RCM Compatibility Issue with John Deere Gen 4 and 5 23-3 Display Bundle

To: Raven Dealers

Date: 5 March 2024

Subject: RCM-Universal and RCM-Sprayer not functioning with John Deere Gen 4 and 5 23-3 displays section control

Figure 2 – John Deere Section Control Information page displaying “No Compatible Implements Detected” which means that RCM is not linked.

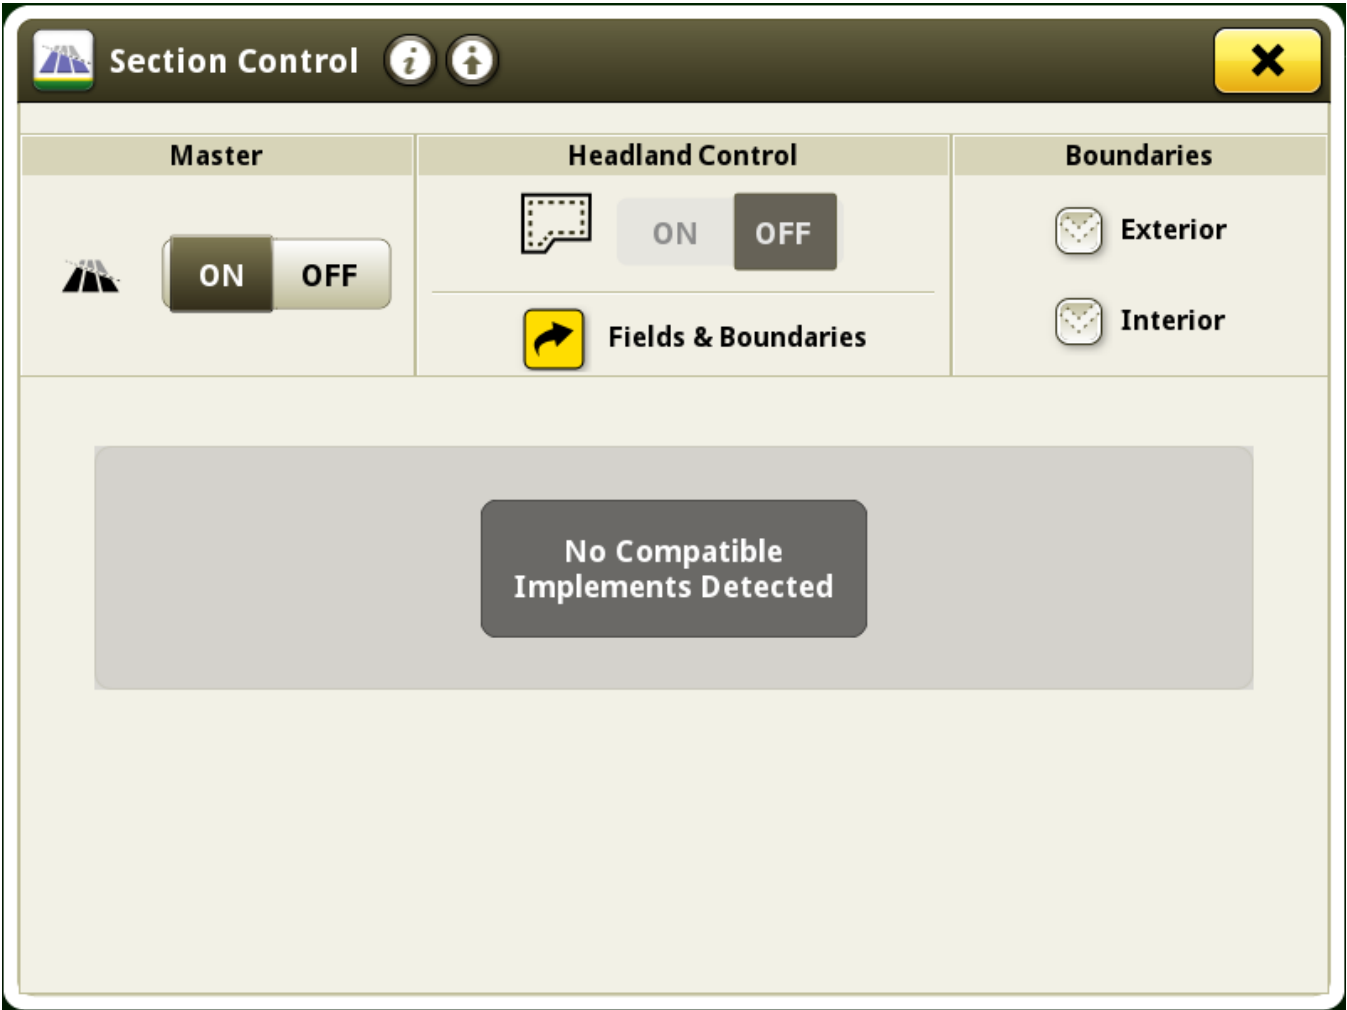
Customers using RCM will not have section control capabilities through the John Deere Gen 4 and Gen 5 displays until a software update is applied to either display (once available) or controller. Refer to Figure 2 for screen capture showing no compatible implements detected.

For the interim, customers have the option of using RCM maintenance software v23.4.3.1 as a workaround. Please visit <https://portal.ravenprecision.com/ProductDocumentation/> for availability. Please note that any expenses incurred for Raven dealer support for installation of this update are the responsibility of the customer.
